GAINES CHARTER TOWNSHIP
PLANNING COMMISSION – REGULAR MEETING
Township Board Room - 8555 Kalamazoo Ave. S.E. Caledonia, MI 49316

DRAFT Agenda

Planning Commission Memo

Planning Commission Memo

Elevation Views

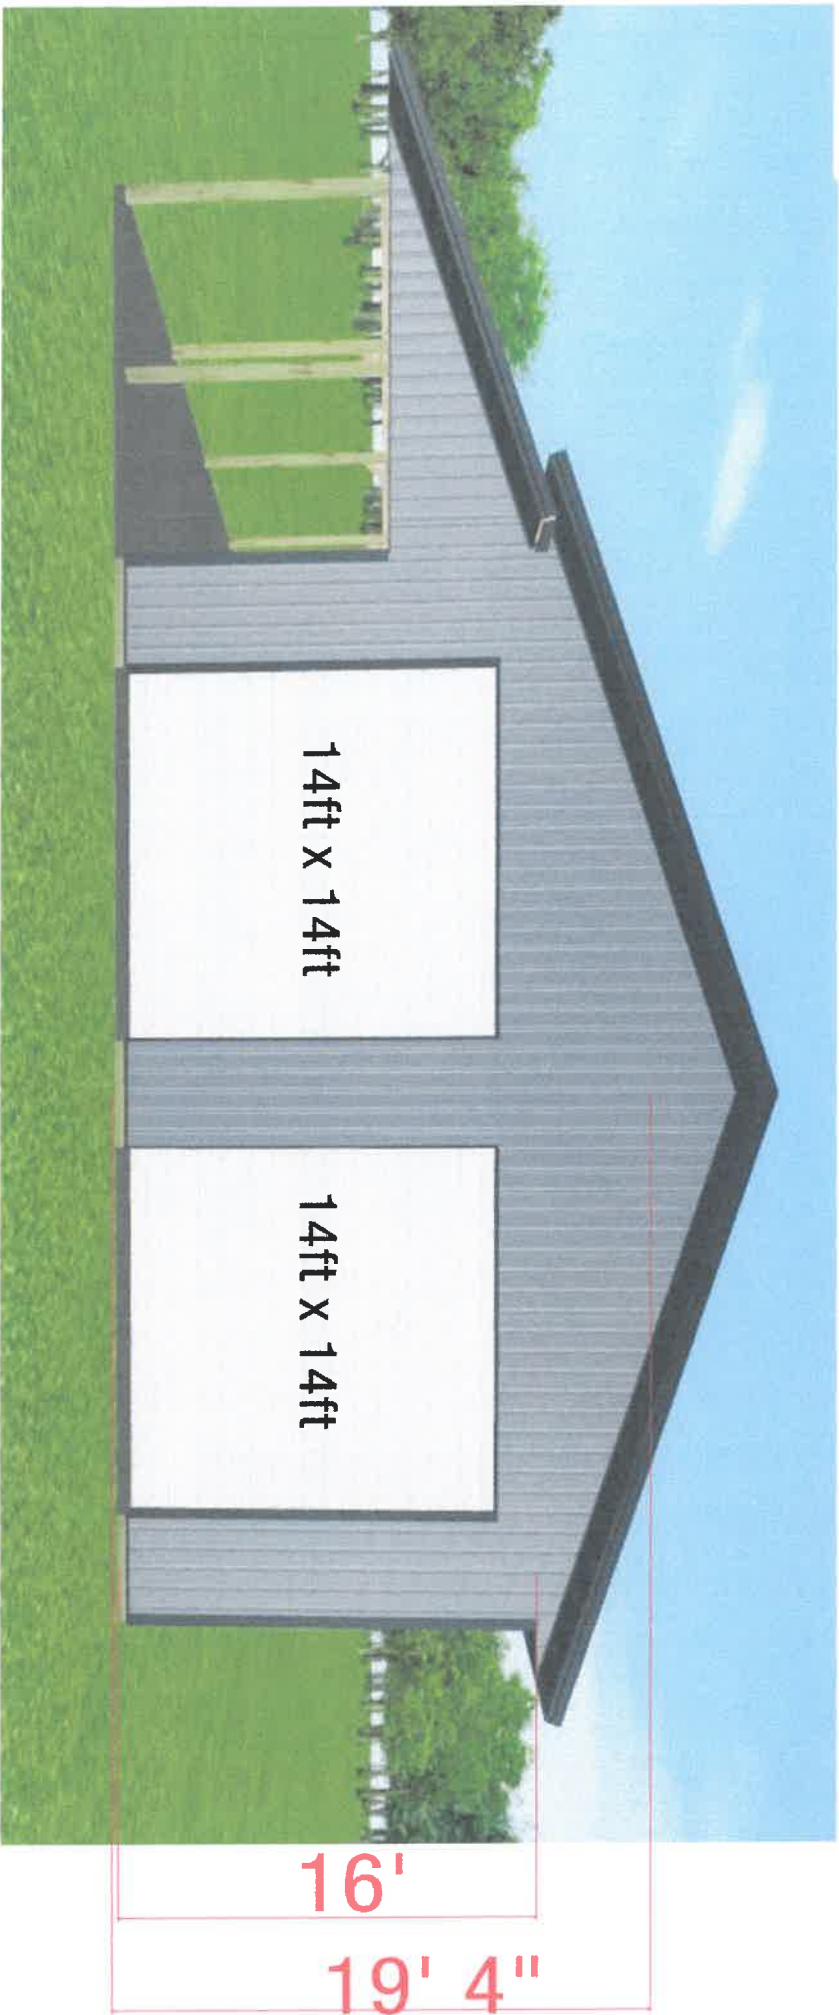
district are limited to a height of 16 feet; the building elevations provided indicate the proposed building as being 19 feet and 4 inches tall. Staff would encourage the applicant to resubmit building elevations that demonstrate compliance with maximum height requirements for accessory buildings as outlined in Section 18.20 of the GCTZO with a subsequent revised site plan before seeking reconsideration from the Planning Commission.
